CITY OF PATASKALA PLANNING & ZONING COMMISSION

STAFF REPORT

April 3, 2024

Planned Manufacturing Application PM-24-001

CITY OF PATASKALA ~ LICKING COUNTY ~ OHIO
RED CHIP 2B
PMD ZONING PLAN
LANDSCAPE PLAN

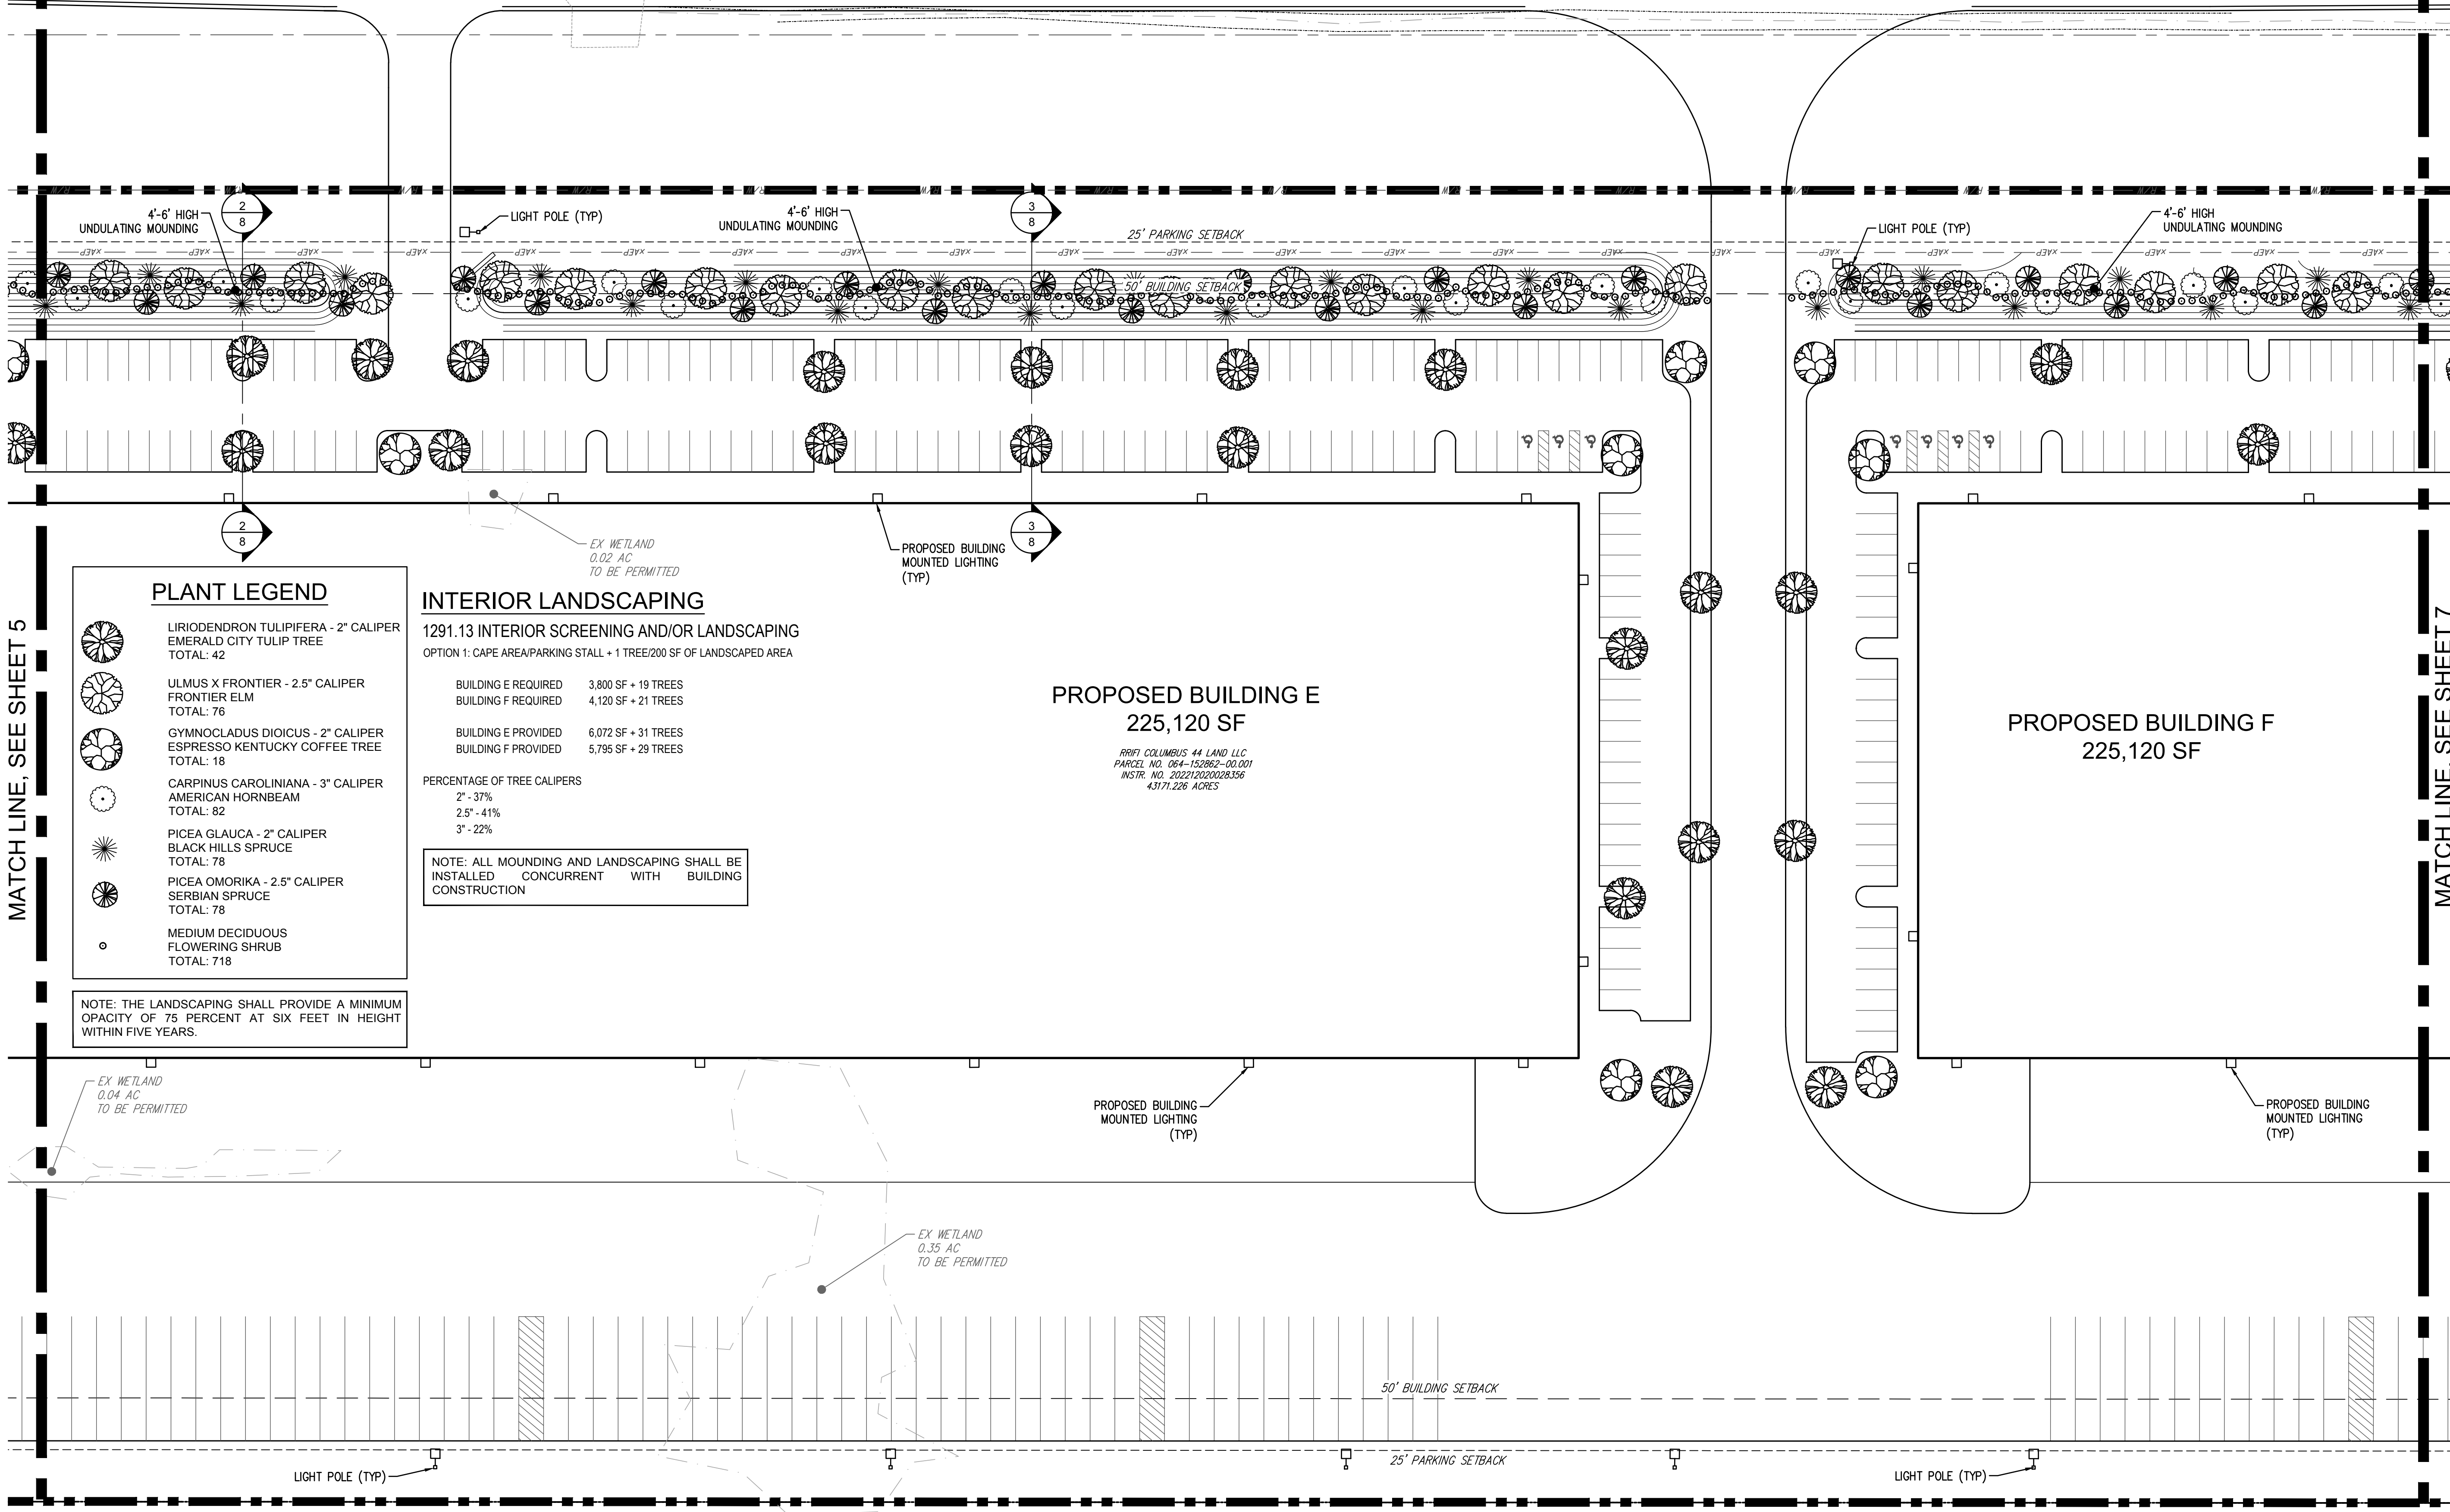
- Does the plant legend account for only trees on the mounding or does it include interior landscaping trees as well? If both, please create separate tables for each.
- 1253.04(E)(3): Tree species shall be native to the region.
 - The following trees are non-native species to the region:
 - Ulmus X Frontier – hybrid cultivar
 - Picea Glauca – non-native
 - Picea Omorika – non-native
 - Final species to be determined with Construction Plans.

- 1253.05(E)(4): Tree spacing appears to be compliant, please include note on plans.
- 1253.05(E)(5) and 1253.05(E)(8): Make note of these sections within the plans.

CITY OF PATASKALA ~ LICKING COUNTY ~ OHIO
RED CHIP 2B
PMD ZONNING PLAN
MOUNDING CROSS SECTIONS

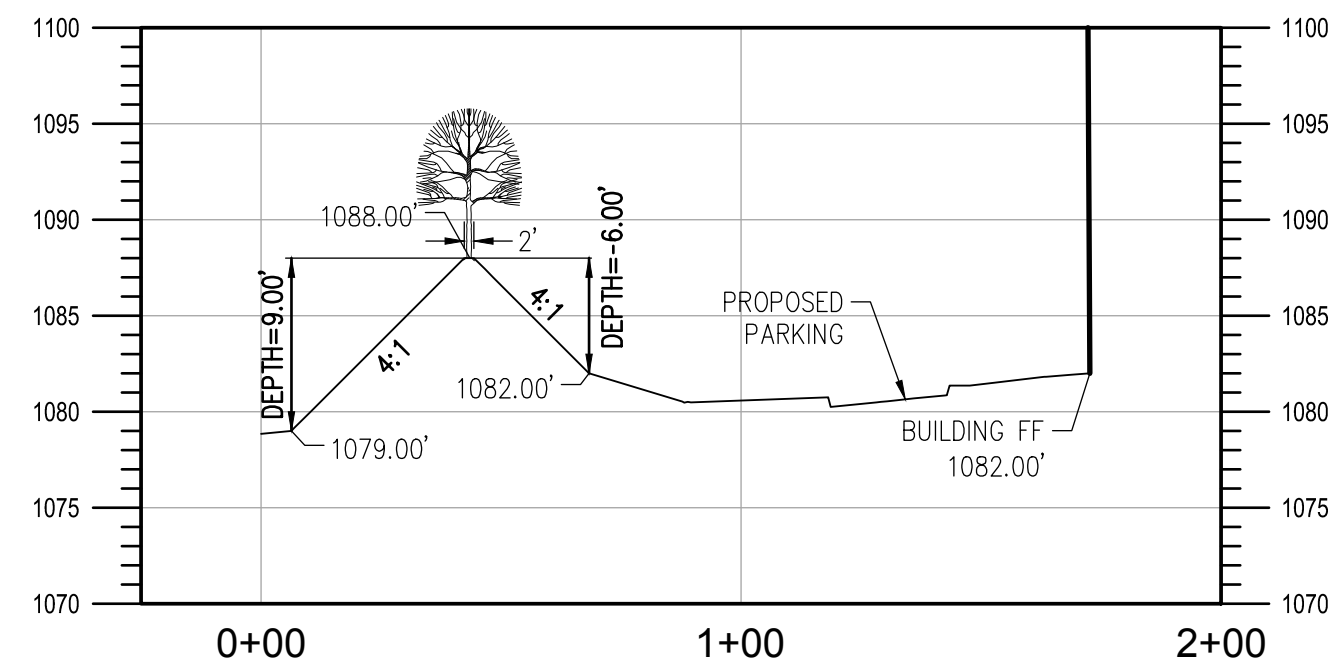
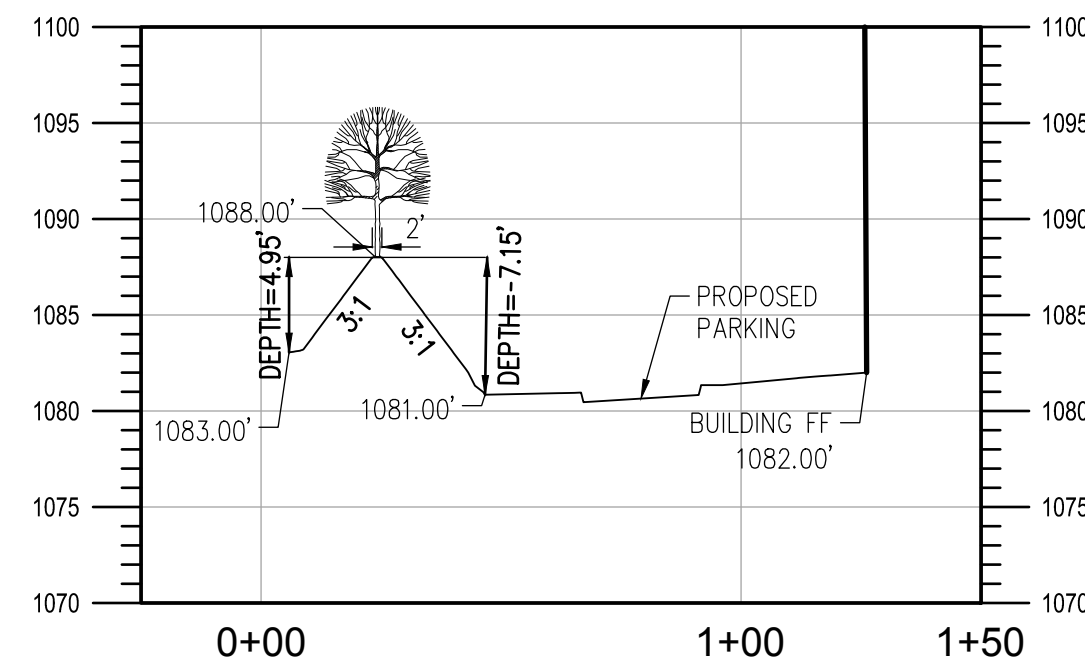
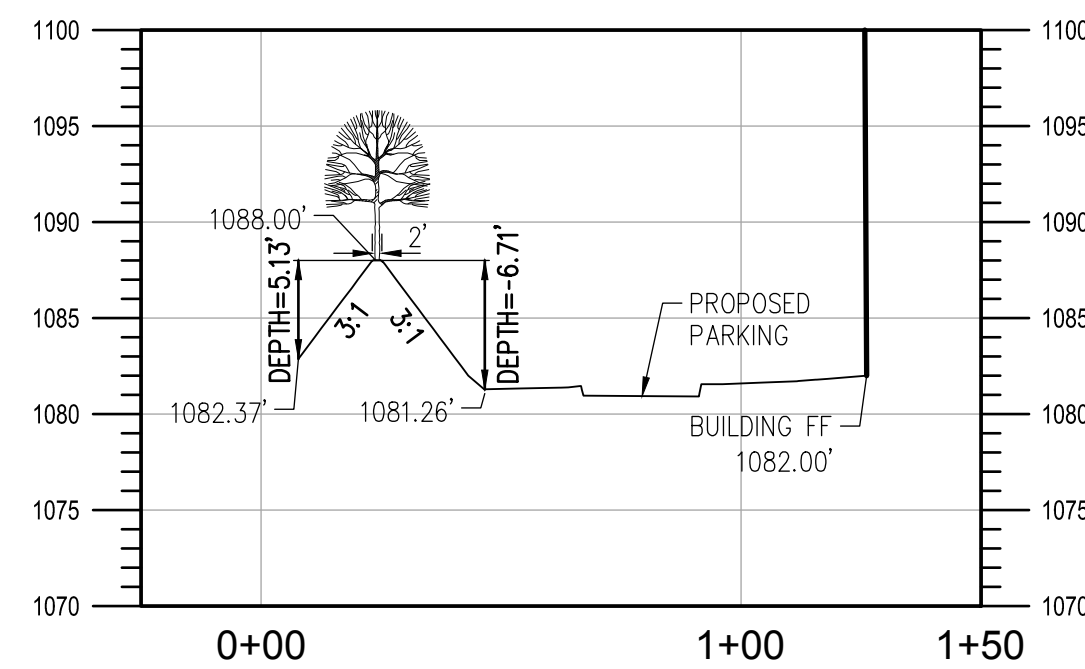
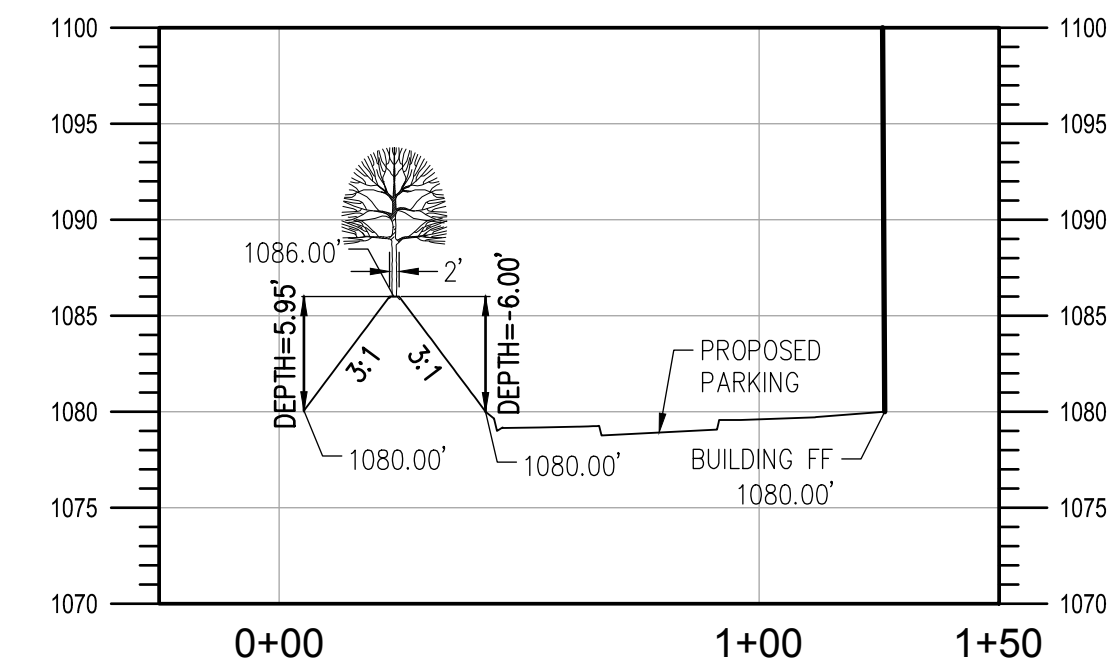
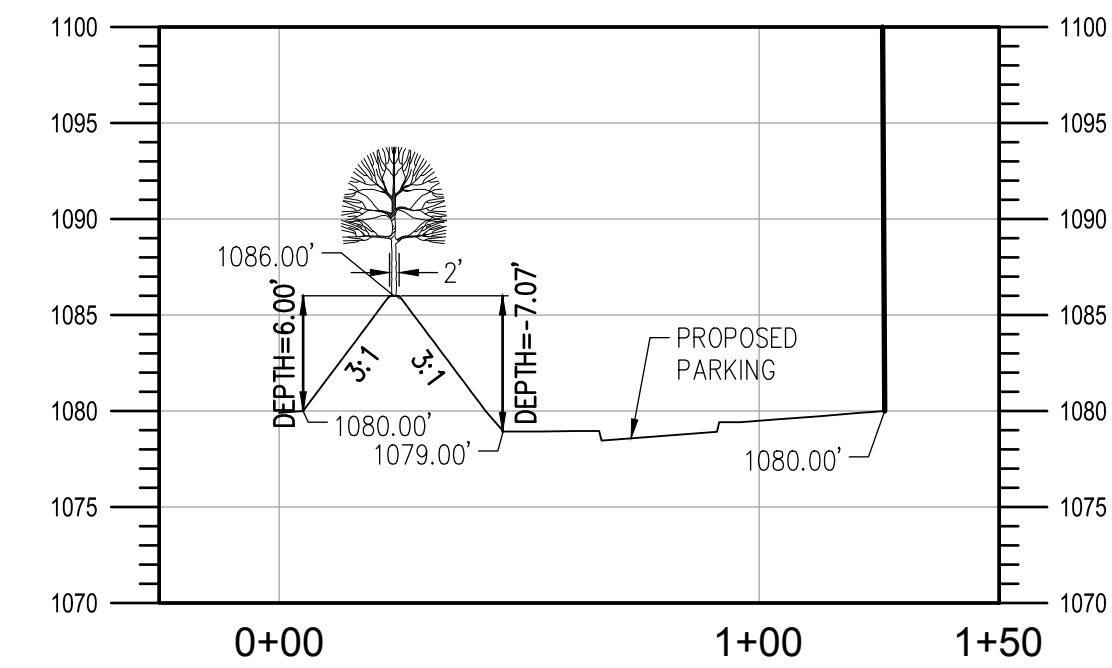
- Provide cross section for 8’-10’ mound along Refugee Road.
- 1253.05(D)(3): Top of mound widths should range from 2-4’, per cross sections only maintaining 2’.
